Rochester ER BRF 0162(18)
VT 73 Bridge # 19
Re: Temporary Concrete Barrier

W.M. Schultz Construction Inc. (WMSCI) would like to request VTRANS to allow us to eliminate where required the use of Energy Absorption Impact Attenuators. WMSCI will extend and locate the end of our Temporary Concrete Barrier outside of the clear zone in our Traffic Control Plan as per the attached drawing. The barrier to the North will extend to the gravel pull off to meet the 1V:1H requirement as well as being set 14' from the edge line of travel. The barrier to the south will be set in such a manner as to terminate behind the temporary transition guide rail that will be coming from the north east corner of the temporary bridge. Concrete barrier supplied by WMSCI will meet the requirements of VTRANS specification section 621 for Temporary Concrete Barrier. The use of the barrier tapered past the clear zone removes the possibility of a direct head on collision with the blunt end and also maintains traffic in the designated path of travel. This allows us to have equipment access to the site by being able to efficiently open and then close the last piece of barrier. For existing field conditions if require

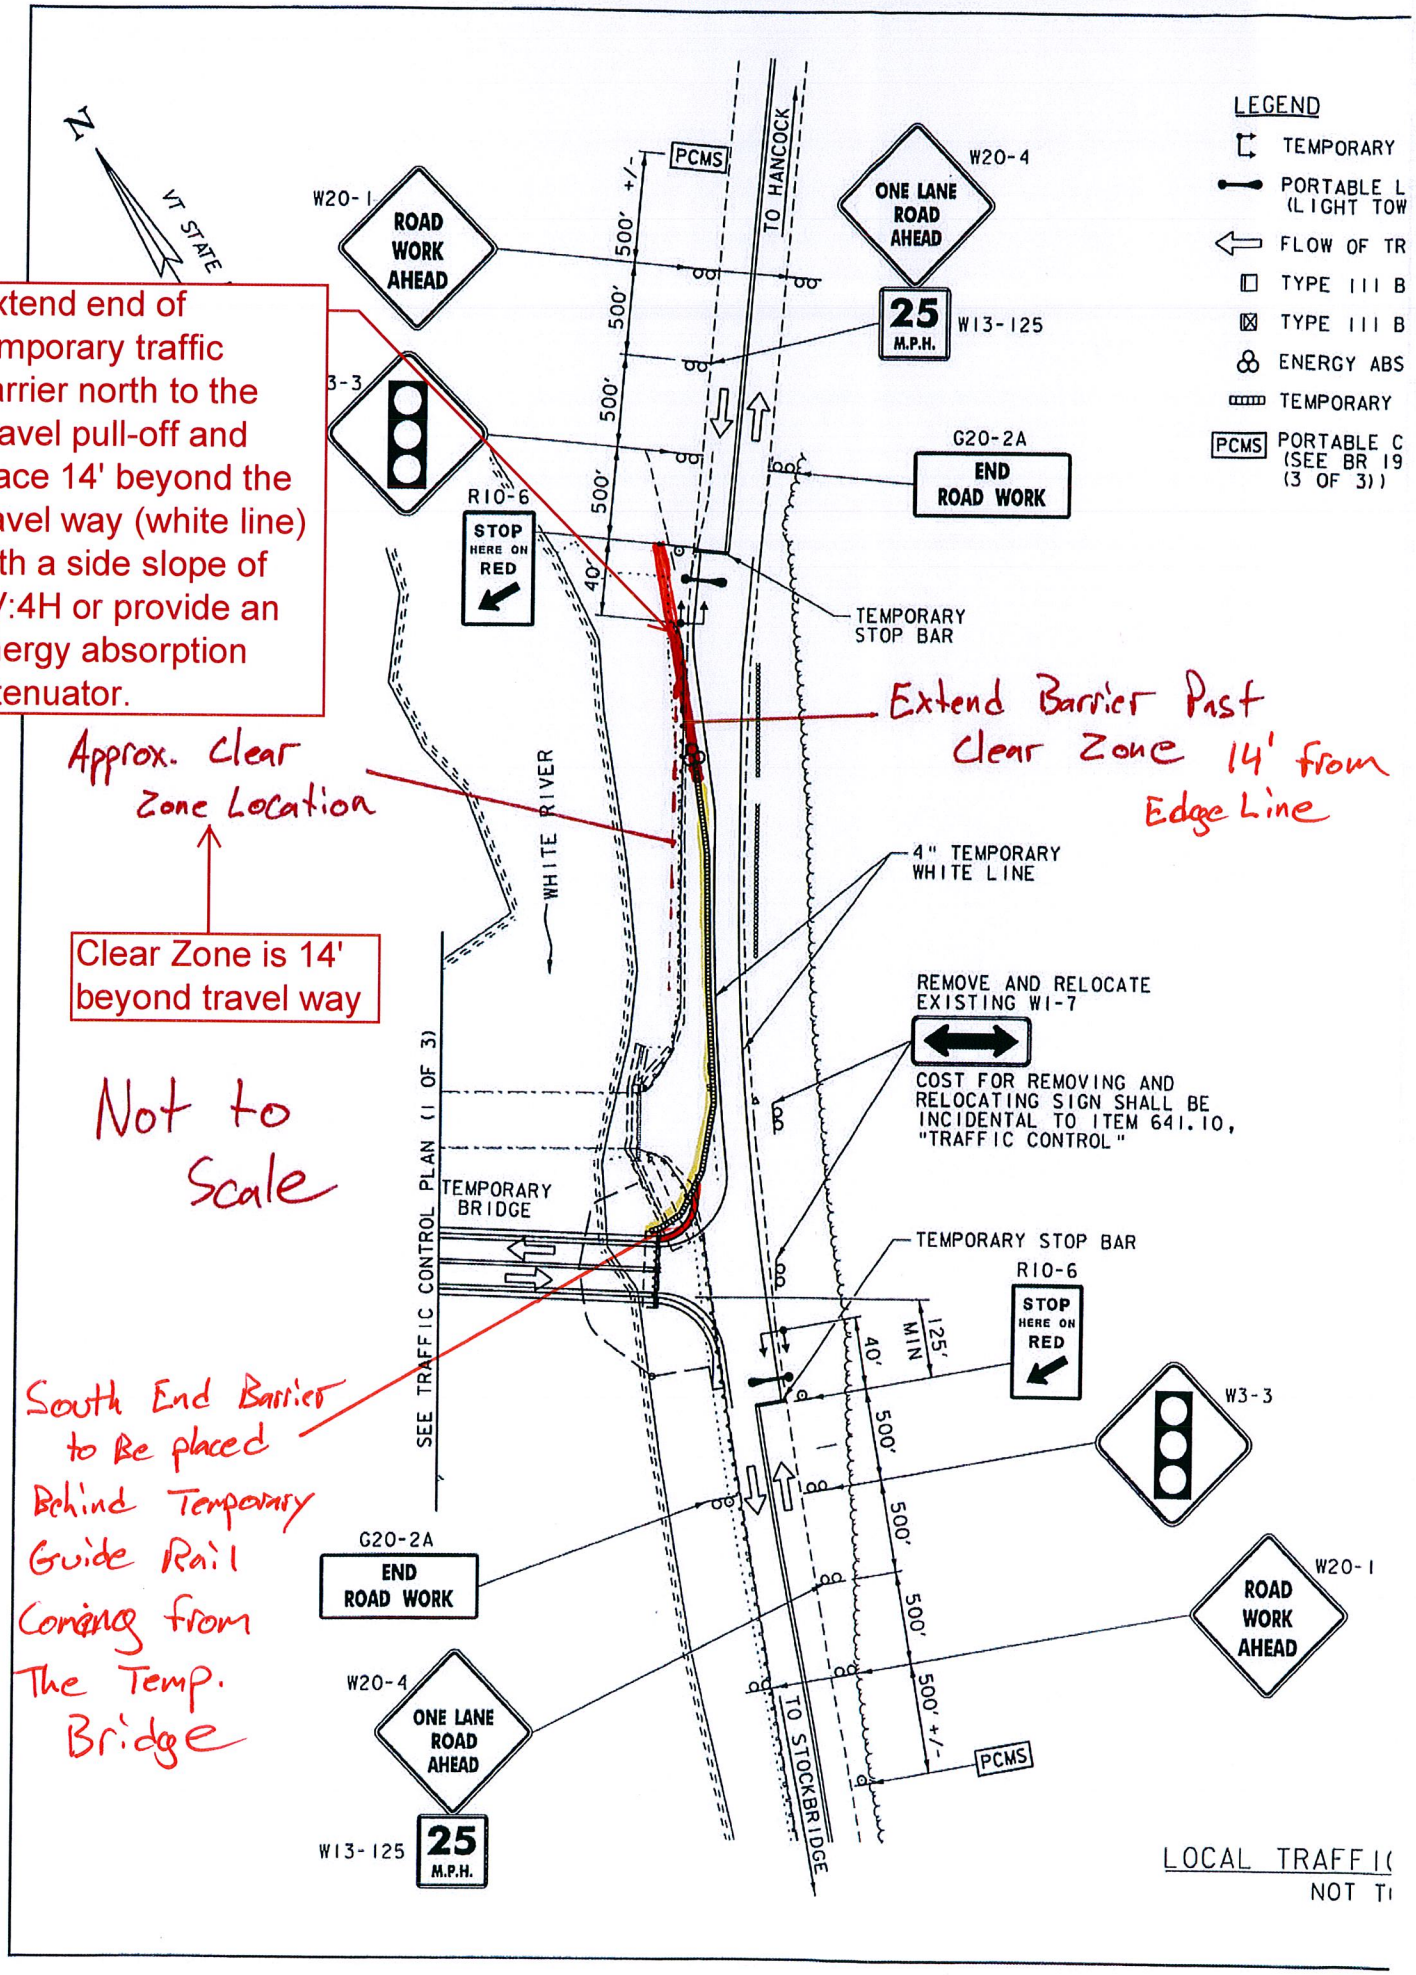
N
VT STATE
W20-1
ROAD WORK AHEAD
W3-3
R10-6
STOP HERE ON RED
PCMS
500' +/-
500'
500'
500'
40'
TO HANCOCK
W20-4
ONE LANE ROAD AHEAD
25 M.P.H.
W13-125
G20-2A
END ROAD WORK
TEMPORARY STOP BAR
Extend end of temporary traffic barrier north to the gravel pull-off and place 14' beyond the travel way (white line) with a side slope of 1V:4H or provide an energy absorption attenuator.
Extend Barrier Past Clear Zone 14' from Edge Line
Approx. Clear Zone Location
Clear Zone is 14' beyond travel way
Not to Scale
WHITE RIVER
4" TEMPORARY WHITE LINE
REMOVE AND RELOCATE EXISTING W1-7
COST FOR REMOVING AND RELOCATING SIGN SHALL BE INCIDENTAL TO ITEM 641.10, "TRAFFIC CONTROL"
SEE TRAFFIC CONTROL PLAN (1 OF 3)
TEMPORARY BRIDGE
TEMPORARY STOP BAR
R10-6
STOP HERE ON RED
125' MIN
40'
W3-3
500'
500'
500'
500' +/-
PCMS
South End Barrier to Be placed Behind Temporary Guide Rail Coming from The Temp. Bridge
G20-2A
END ROAD WORK
W20-1
ROAD WORK AHEAD
W20-4
ONE LANE ROAD AHEAD
